Seabrook Station
License Amendment Request 99-02, Revision 1,
"Operation with Relaxed Axial Offset Control"

SEABROOK STATION UNIT 1

**License Amendment Request No. 99-02, Revision 1,
"Operation with Relaxed Axial Offset Control"**

FIGURE 2.1-1

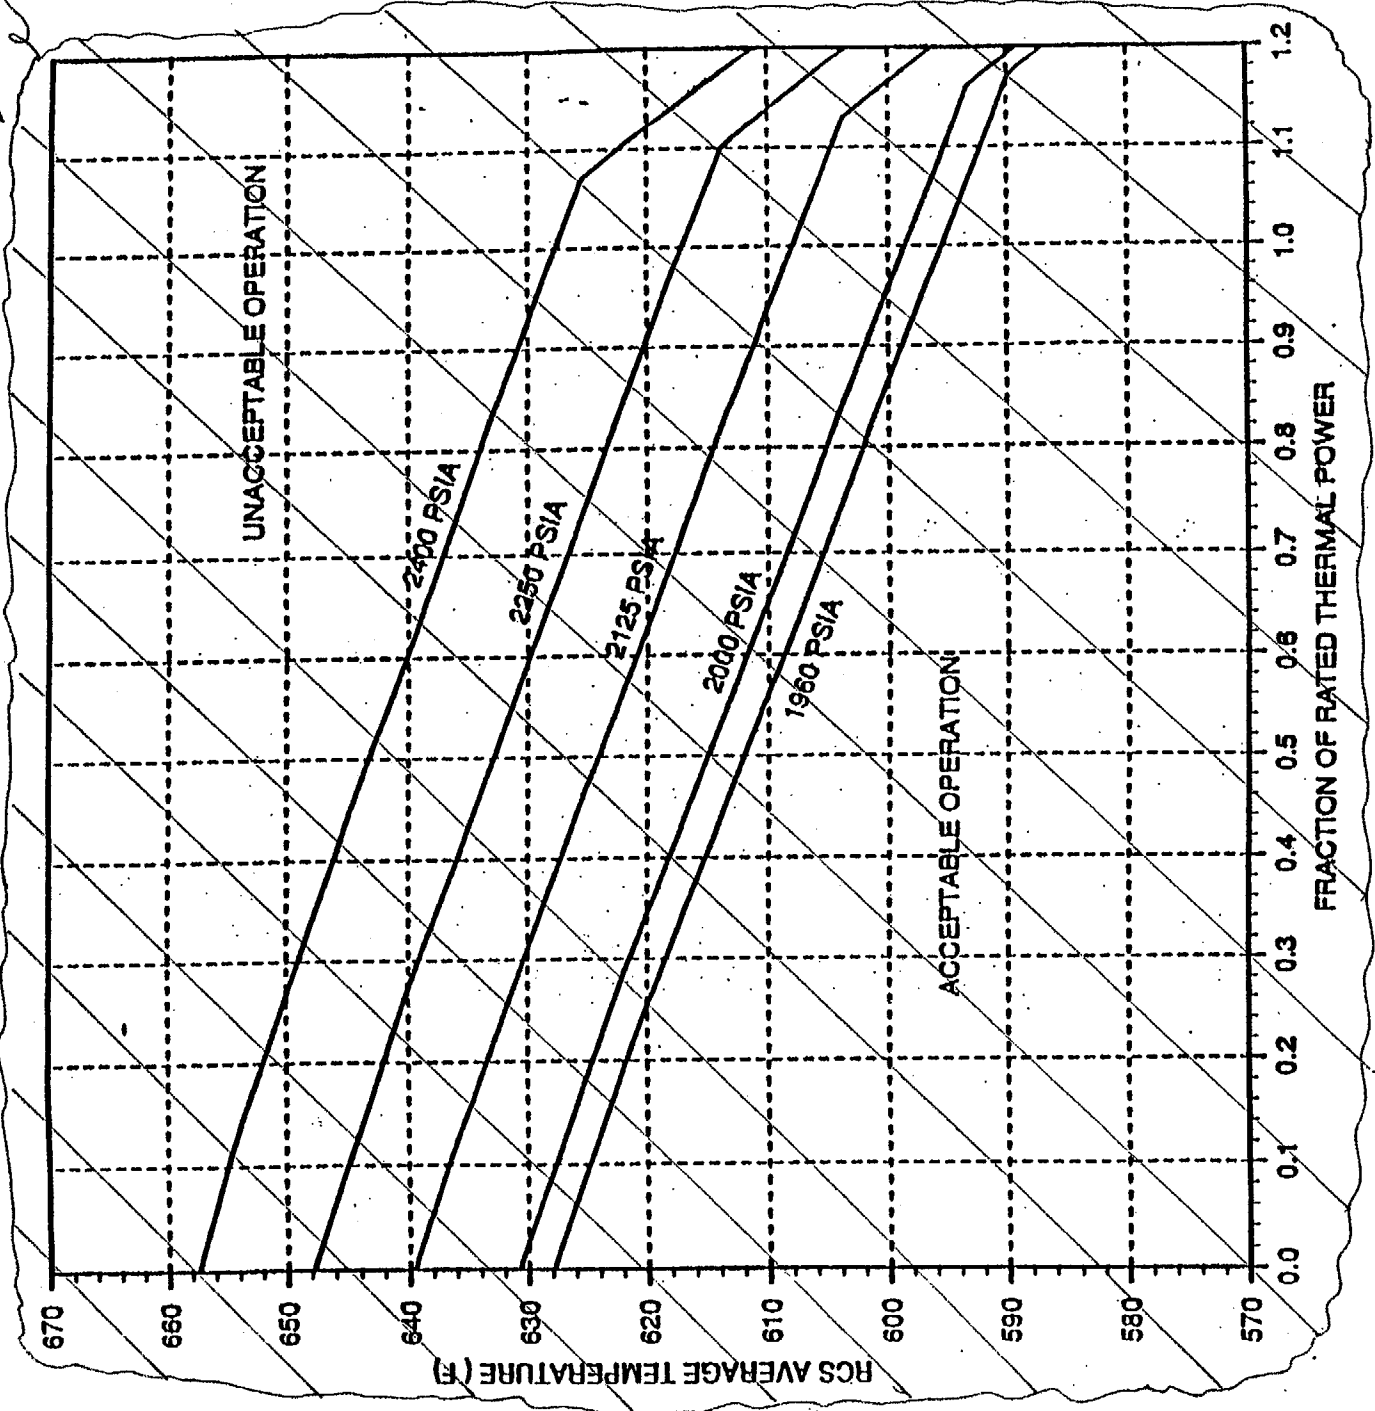
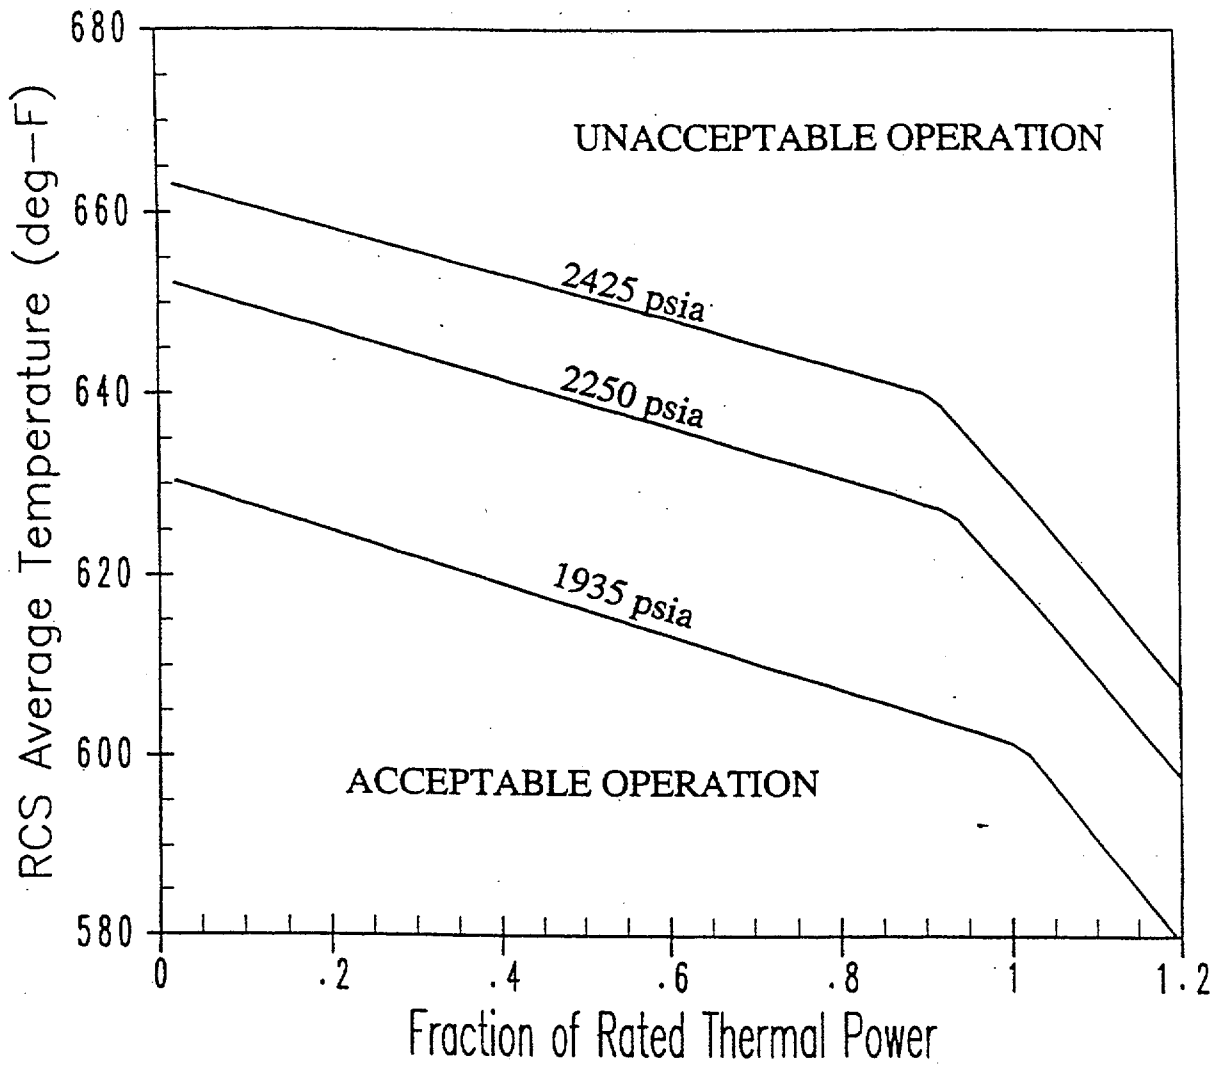
Revision to TS Figure 2.1-1 thermal limit lines. The existing, approved, Reference [3], thermal-hydraulic analysis of the 17x17 VANTAGE+ (w/o IFMs) fuel is based on the Revised Thermal Design Procedure (RTDP) and the WRB-1 DNB correlation. Thus, the thermal limit lines in the Technical Specifications reflect approved analysis methodology applied to the current fuel design, VANTAGE+ (w/o IFMs). The DNB analysis of Cycle 8 and subsequent transition cores containing both 17x17 VANTAGE+ (w/o IFMs) and 17x17 VANTAGE+ (w/ IFMs) fuel assemblies has been modified to incorporate the WRB-2 DNB correlation, RTDP, and VIPRE modeling as licensed by Westinghouse (References [1], [4], [5], and [6]). Therefore, the proposed changes to the thermal limit lines reflect updated and approved thermal-hydraulic analysis methodology applied to the new fuel, VANTAGE+ (w/IFMs).

REPLACE WITH ATTACHED NEW FIGURE 2.1-1

NEW FIGURE 2.1-1
